VERMONT YANKEE NUCLEAR POWER CORPORATION

> May 4, 2001 BVY 01-40

Subject:Vermont Yankee Nuclear Power StationLicense No. DPR-28 (Docket No. 50-271)Revision of Technical Specification Bases Pages

Technical Specification Bases Revision

91

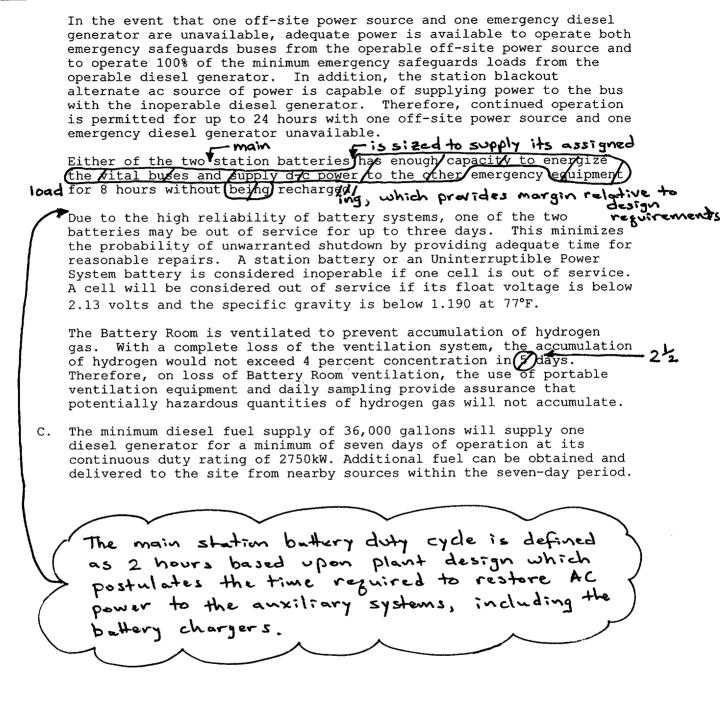
Bases page 91 has been revised to generalize reference to the MCPR limiting transient. This editorial change revises the wording to describe how the limiting transient is determined each operating cycle.

determined based on

delta

the limiting power

Each operating cycle,

The Control Rod System is designed to bring the reactor subcritical at a rate fast enough to prevent fuel damage. Each operating cycle, the limiting power transient delta CPR is determined based on the average response of all the drives given in the above specification to ensure that the MPCR remains greater than the fuel cladding integrity safety limit.
